WORKSHOP AGENDA

Planning Commission

April 15, 2025 @ 5:30 PM

For the April 29, 2025 Regular Meeting @ 6:00 PM

PER ORDINANCE SECTION 14-603(5)(C)(I) STORM DETENTION CALCULATIONS

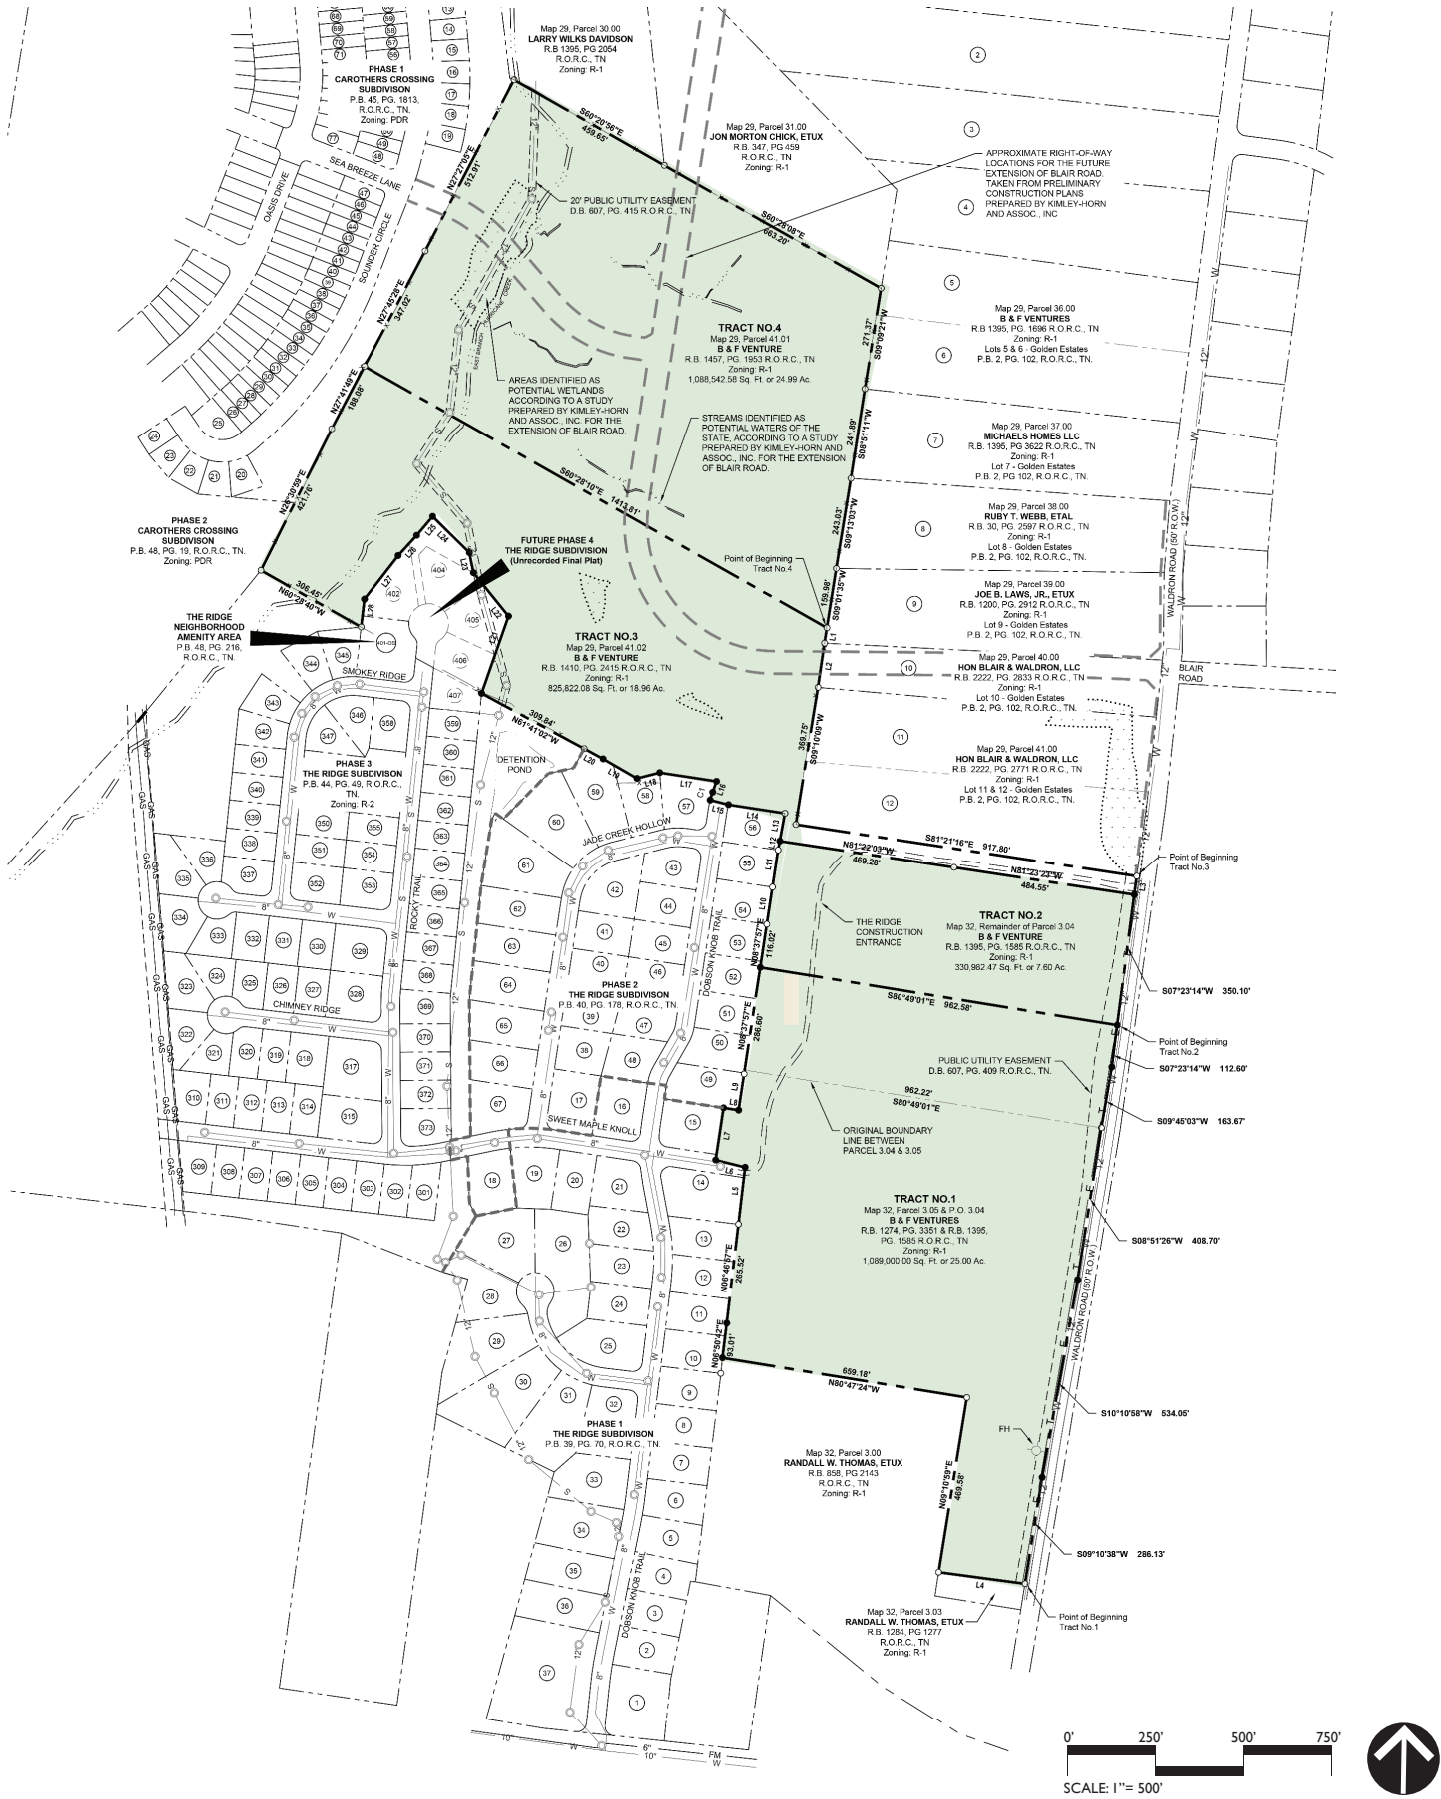
1. The requested hydraulic calculations required by the La Vergne Stormwater Management Ordinance Section 14-603 (5) (c) (i) for Concept Plans were not submitted. The exhibits that were submitted on 03 April 2025 were insufficient for engineering review. The developer's engineer was provided with a listing of the items required at this stage by the Stormwater Management Ordinance on 04 April 2025. The items that are still outstanding are as follows:

- g. Provide a table comparing the peak flow rates resulting from the above three hydrograph calculations

Arbor Ridge - Section 11

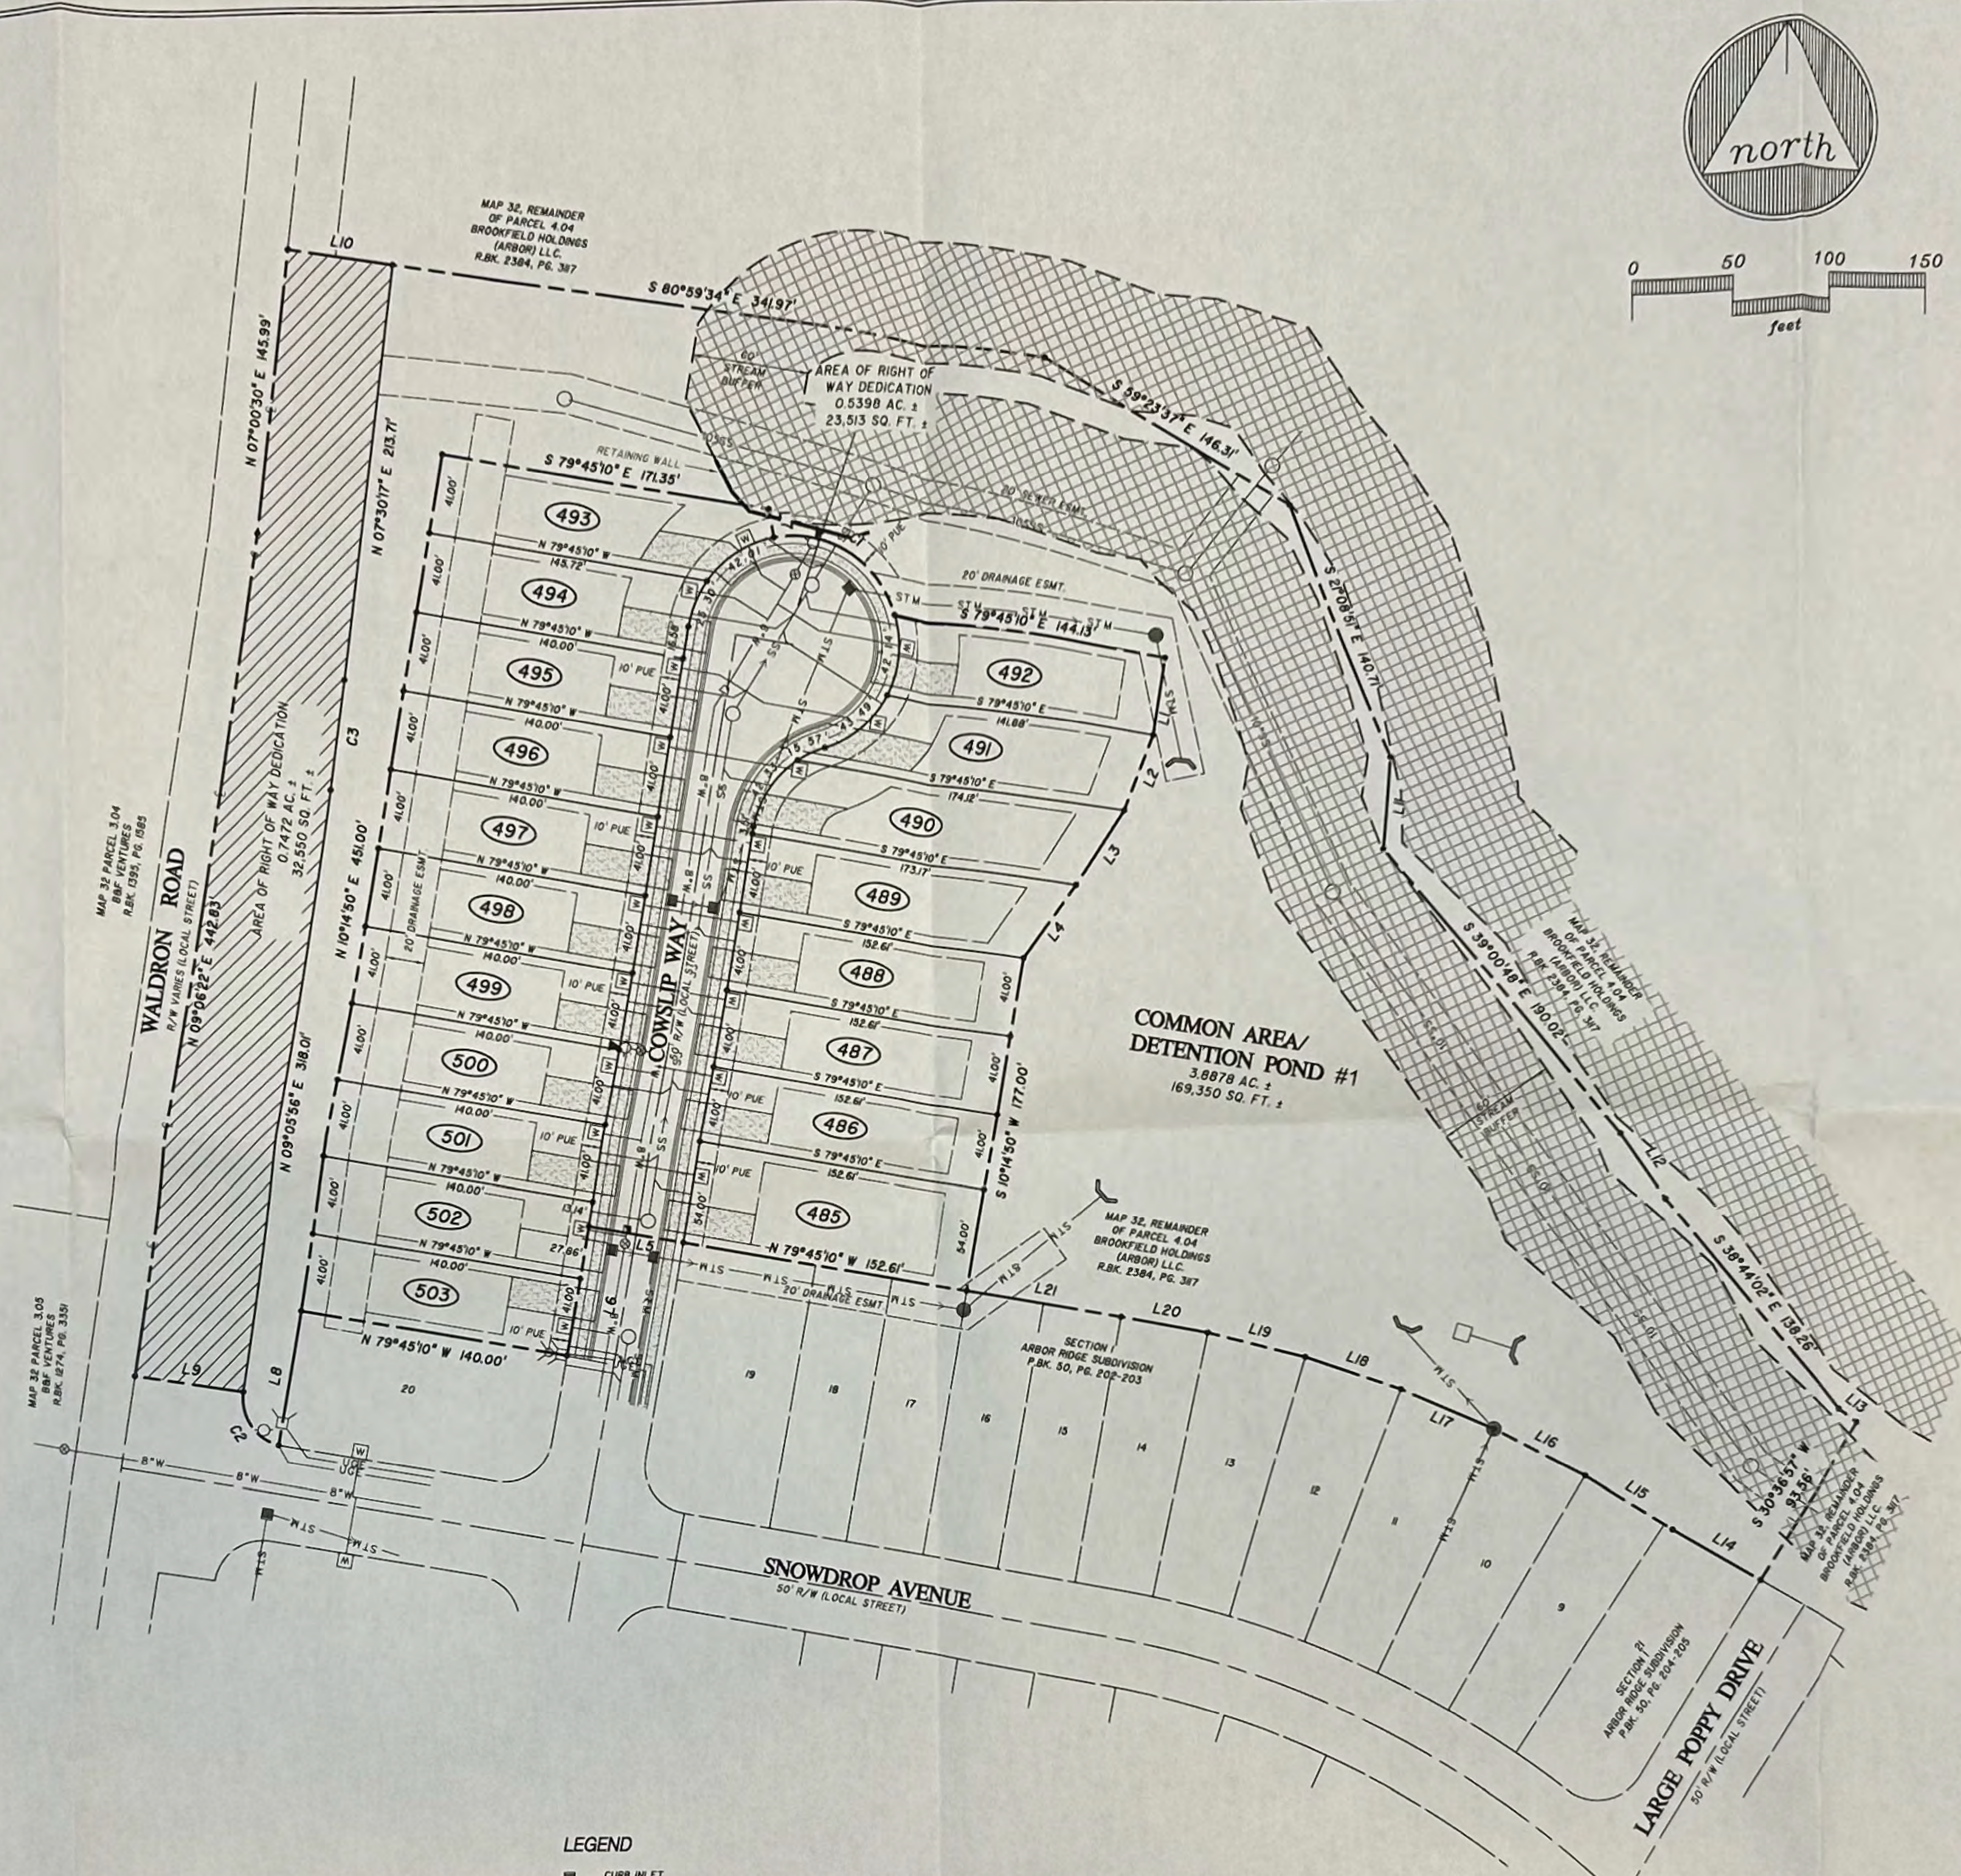
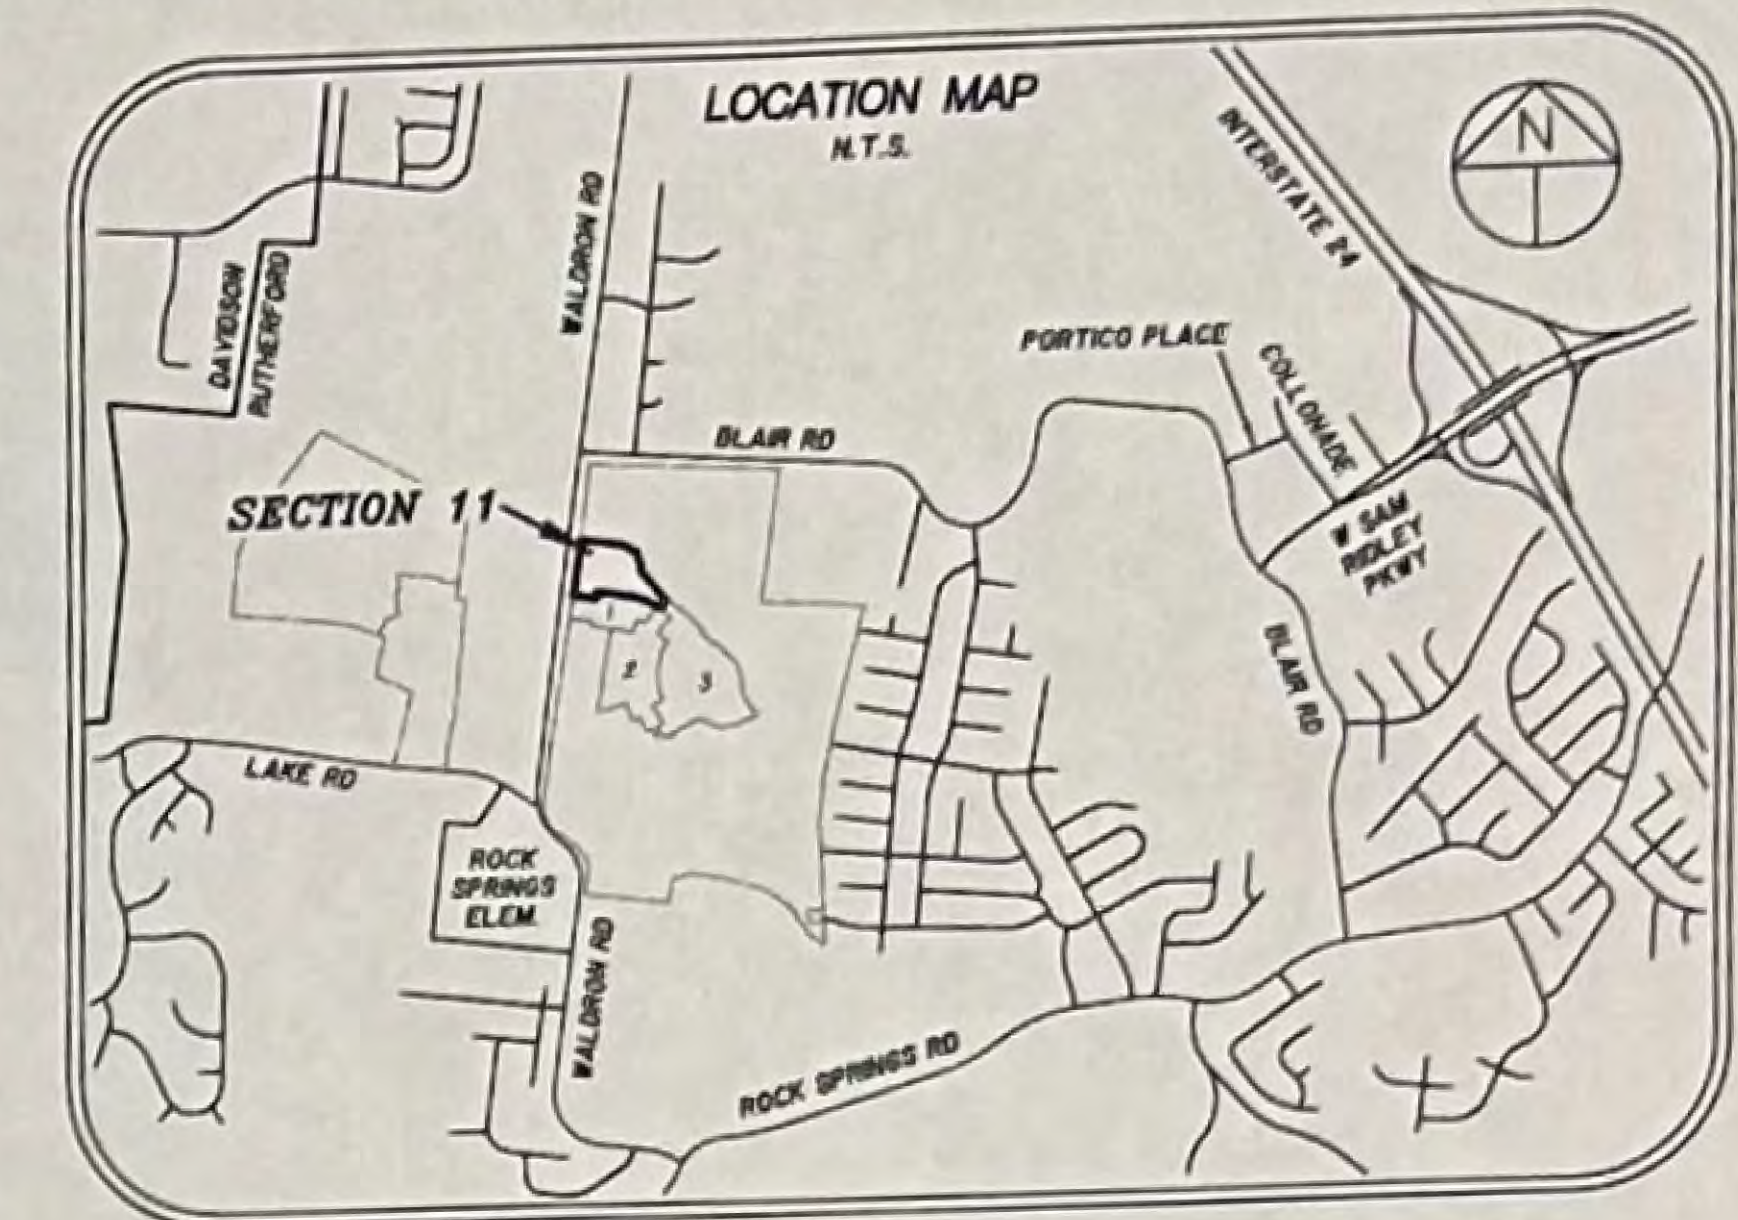
1. Show a sewer lateral for Lot 496.
2. Under Certificate of Approval of Water System (bottom right of sheet) – update text from *Arbor Rdige Section 3* to *Arbor Ridge Section 11*.
3. Under Certificate of Approval of Sewer System (bottom right of sheet) – update text from *Arbor Rdige Section 3* to *Arbor Ridge Section 11*.
